# **PRODUCT CHANGE NOTICE**

**Alternate Manufacturing Site  
for Assembly of the Listed  
Intersil QSOP and SC-70  
Packaged Products**

**Refer to:  
PCN12091**

**Date: December 4, 2012**

# PCN12091 – Current POD QSOP 16I and 24I

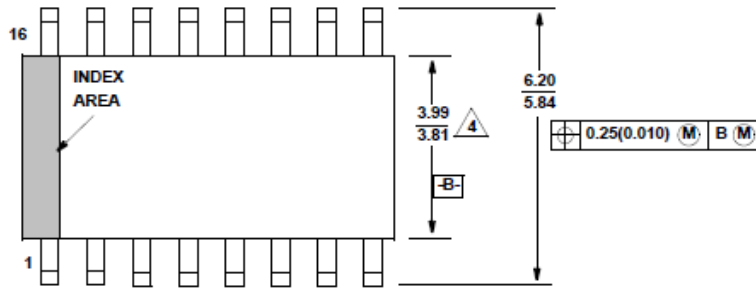
The Carsem (CAM) facility is ISO 9001:2008, TS 16949:2009, and ISO 14001:2004 certified. The CAM facility is qualified as a supplier to Intersil for performing assembly of packaged products, including the QSOP and SC-70 package styles. There will be no change in the die attach, bond wire (material or diameter), frame material, or moisture sensitivity level (MSL). The 16I QSOP, 24I QSOP, and select 6I SC-70 packaged devices will require minor dimension changes to the package outline drawings (POD). The affected PODs and a summary containing a list of products along with the current and new PODs are included for reference. The material set combinations for assembly and other key items are as follows:
